Changes Made to Development Permit Documents

Bubbled Set
Changes made to the
Development Permit Application

902 Foul Bay Road
Victoria B.C.

Revised Development Permit Application
April 26, 2024

East Building - E-W Section

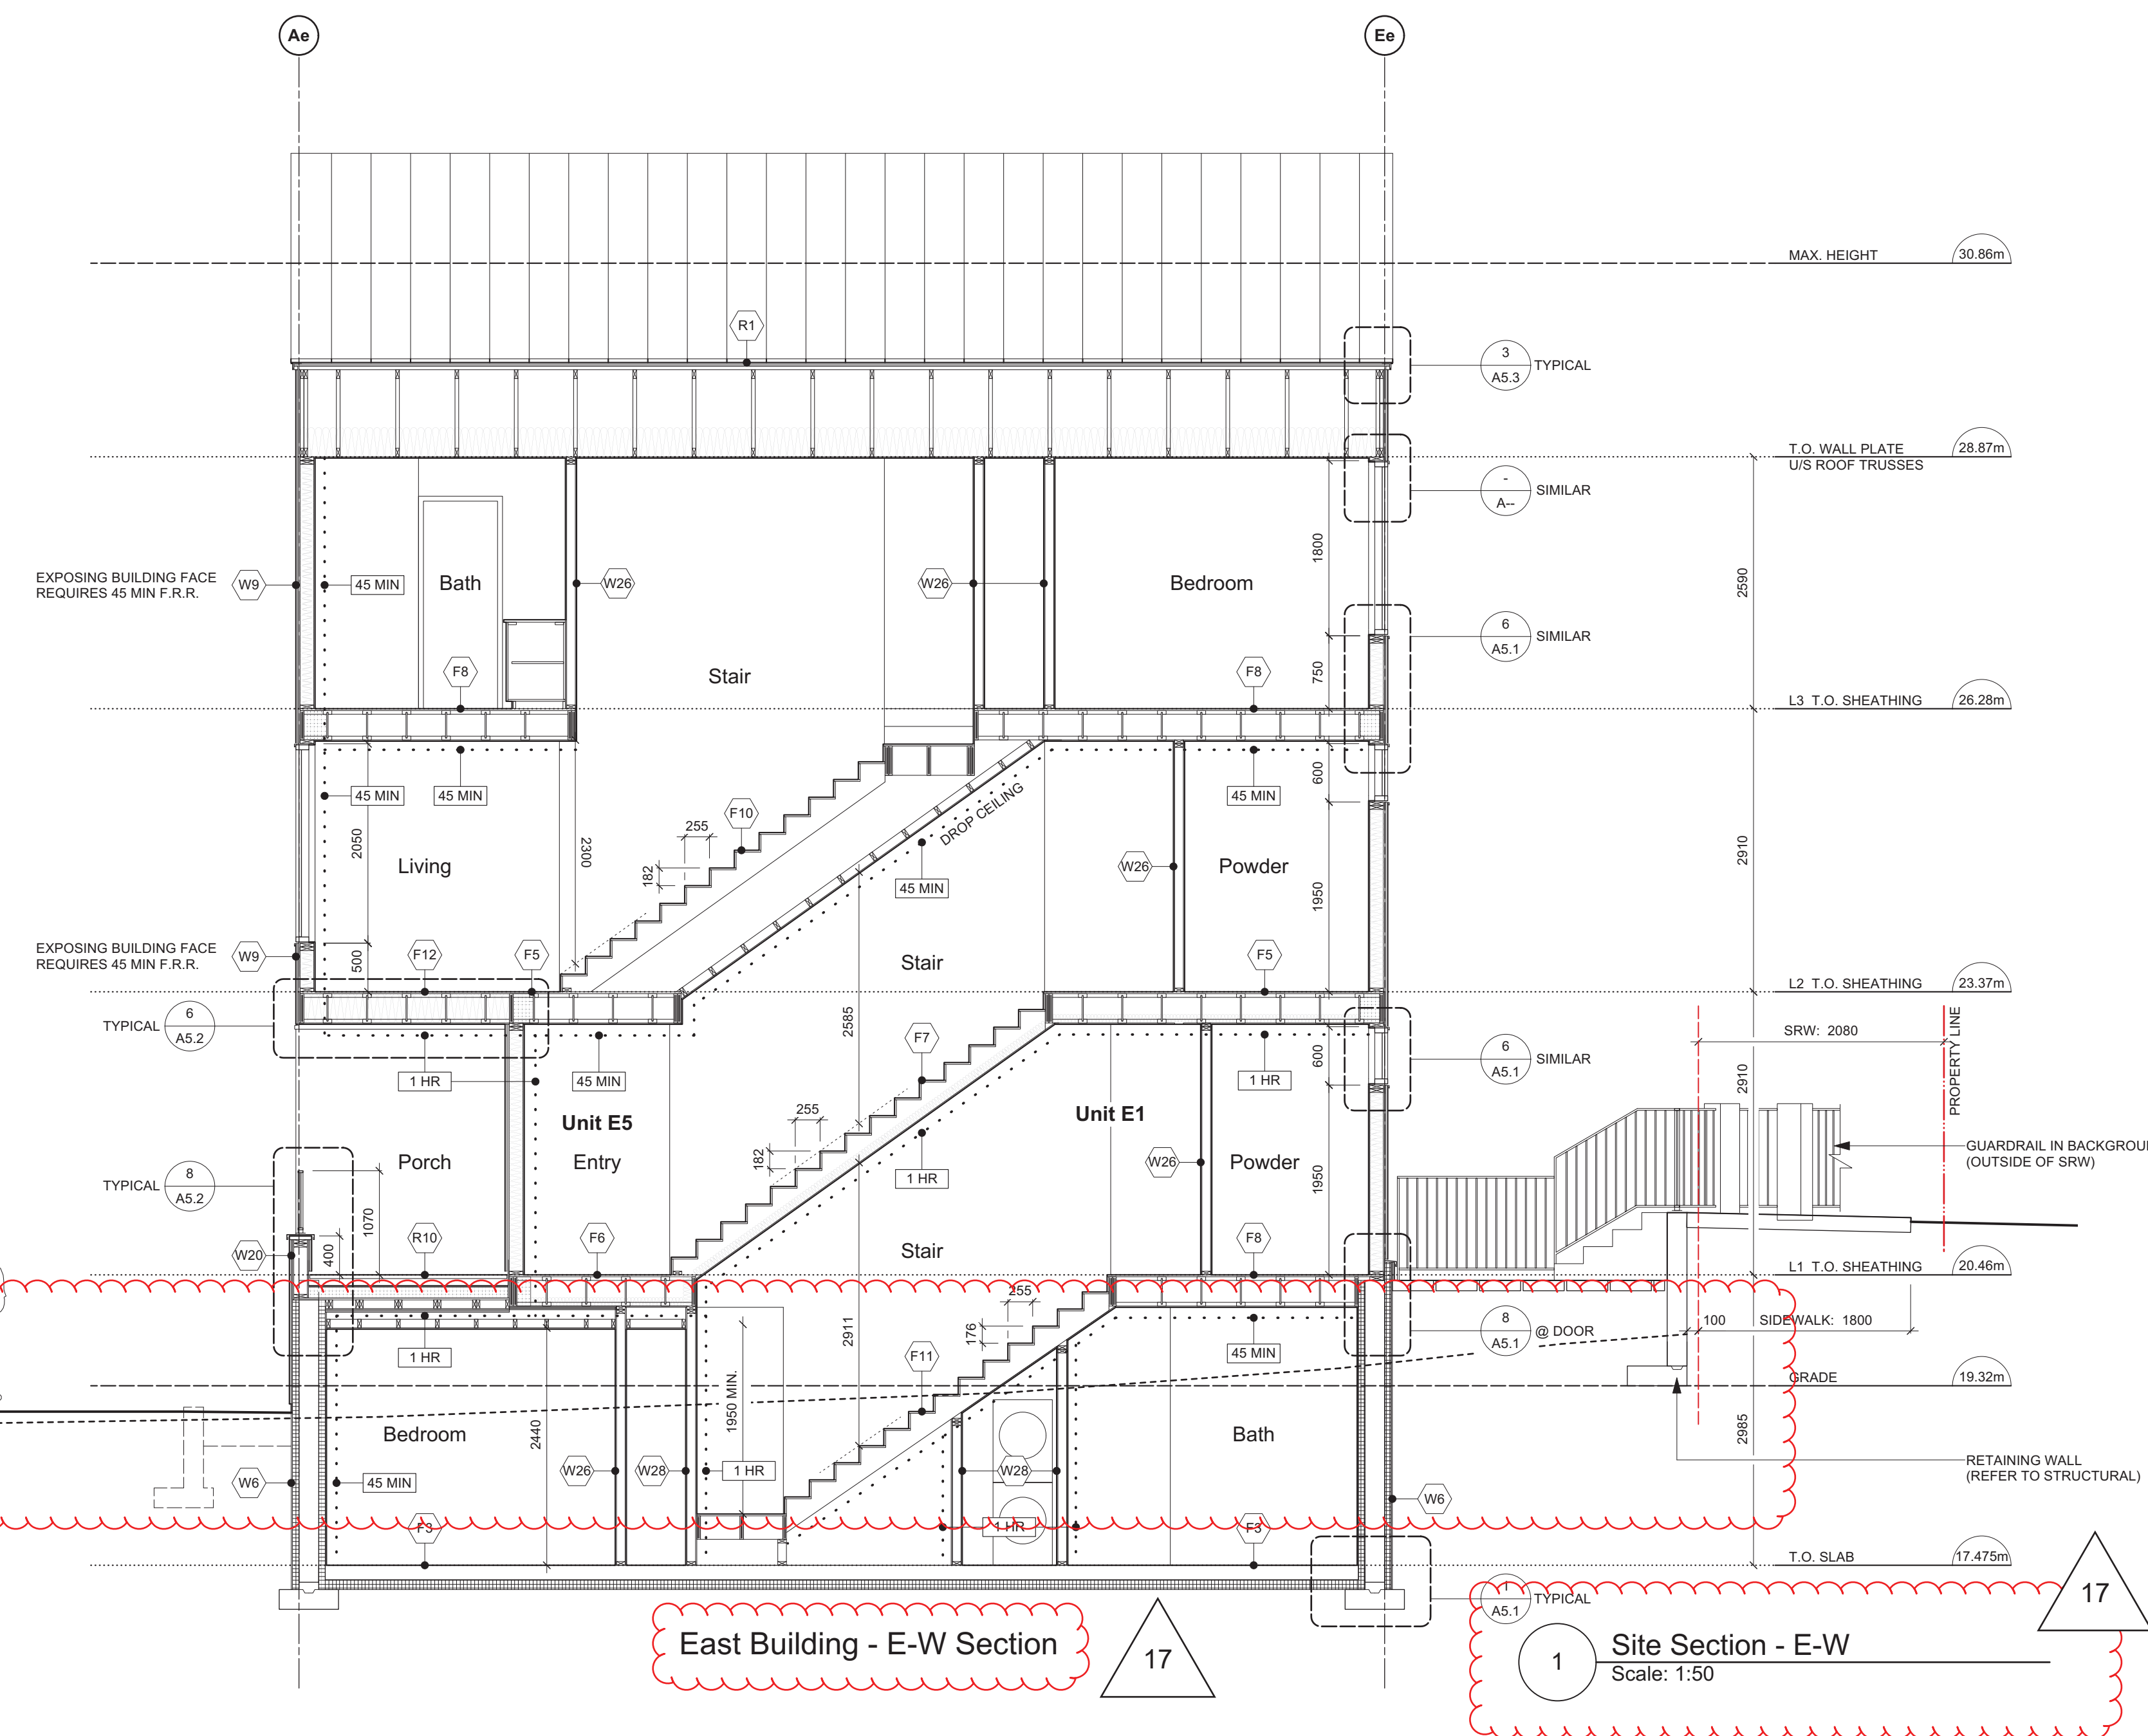
17	Section Label Revised	A4.1	Section drawing labels revised to "East Building", "West Building" and "Site" in response to Zoning Plan Check Comment.
18	Materials Palette Added	A3.4	Added back into set with new sheet number. Material #7 has been deleted and replaced (see revision #6 above).
19	Stairs & Retaining Walls Adjusted	Site Plan & A2.1w	At the West Building, entry porch stairs have been reduced in length and window well retaining walls have shifted east to suit refinements in finished grade. Grade points at retaining walls and new building corners have been re-extrapolated from the survey. See revision #7 above.
20	Stairs Adjusted & New Retaining Walls	Site Plan & A2.1e	At the East Building, window wells have been added and entry porch stairs have been adjusted in length to suit refinements in finished grade. Grade points at new building corners and retaining wall steps have been re-extrapolated from the survey. See revision #7 above.
